Ducted Systems Technical Services Service Tips Letter

Letter: **ST-007-2019**

Subject: **Control Software Change – Variable Capacity Outdoor Control / Outdoor Display.**

Product: Residential Split System variable capacity heat pump and air conditioning models YZV, HC20, HL20, YXV, AC21, AL21

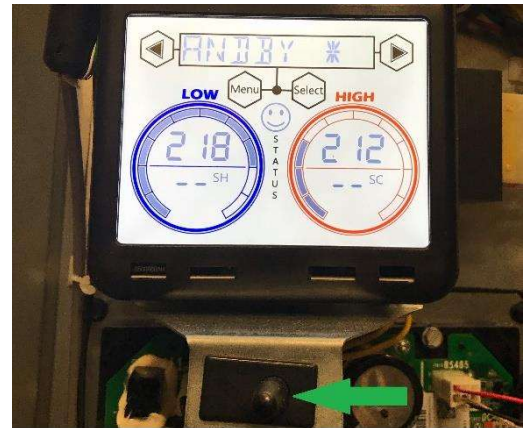
The model numbers listed above contain an outdoor control with an interactive touch screen display that is used for unit installation, control setup, equipment service, and diagnostics. The touch screen display contains a backlight feature and display is activated by a door switch located below the display as shown below.

The door switch utilized is a normally open switch. The switch is connected to the DOOR SWITCH terminal on the outdoor control using a wire harness that contains two yellow wires. When the door switch circuit is open, the backlight and display are activated. We have received complaints of damage to the door switch under normal use and service. The damage results in the door switch being stuck either open or closed. Since the variable capacity control activates the display when the door switch circuit is open, the end user can still use the control by unplugging the switch harness from the DOOR SWITCH terminal.

To improve product quality the door switch will be removed on new production units. Due to this, a new version of the software is required for the outdoor control. The variable capacity product is controlled by a touch screen HX™ thermostat. Software updates for this system are sent “OTA” (over the air.) On 05/10/2019 outdoor display software version, 1.08 will be sent out via a mass OTA update. Any system connected to Wi-Fi via the HX™ thermostat should receive this update. Once the update takes place, the outdoor unit door switch circuit will become inactive.

If a field installed unit is not connected to Wi-Fi it will not receive a software update. If the door switch fails and the control software is not at least version 1.08, the switch must be replaced with switch part number S1-02435738000.

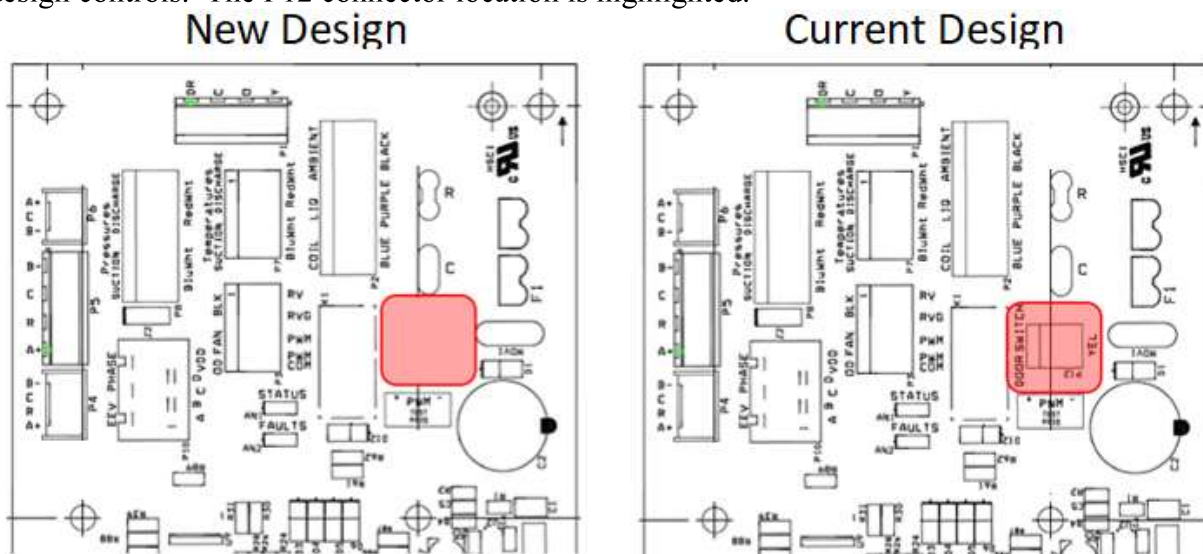
Backlight and Variable Capacity outdoor control activation will be controlled by the navigational response from either the MENU and/or SELECT buttons once the control contains software version 1.08 or higher.

Upon unit power-up, the control display will be on for 60 minutes. If the control does not receive a navigational response for greater than 60 minutes, the control will turn off the display.

Awake-Energize Display: If the controls sense a navigational response from **either** the MENU or SELECT buttons greater than 2 seconds, the control will turn on the display. If the control does not receive a navigational response for greater than 60 minutes, the control will turn off the display.

De-Energize the Display: If the controls sense a navigational response from **both** the MENU and SELECT buttons greater than 5 seconds, the control will turn off the display.

To turn the display on – hold down the MENU or SELECT button for > 2 seconds.

To turn the display off - hold down the MENU and SELECT buttons for > 5 seconds.
